BTB 51970-52683 REV2 (1409)

Recall: Driver's Airbag Inflator May Produce Excessive Pressure After Long-Term Exposure to High Absolute Humidity

Supersedes 14-029, dated September 12, 2014; to revise the information highlighted in yellow

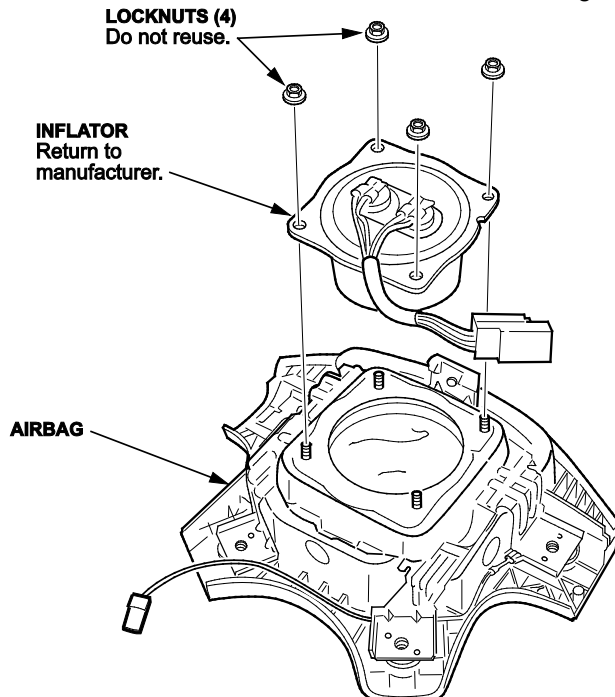
6. Using needle-nose vise grips **or a 3/8 in. 6-point socket**, remove the four locknuts from the inflator. The locknuts will not be reused.
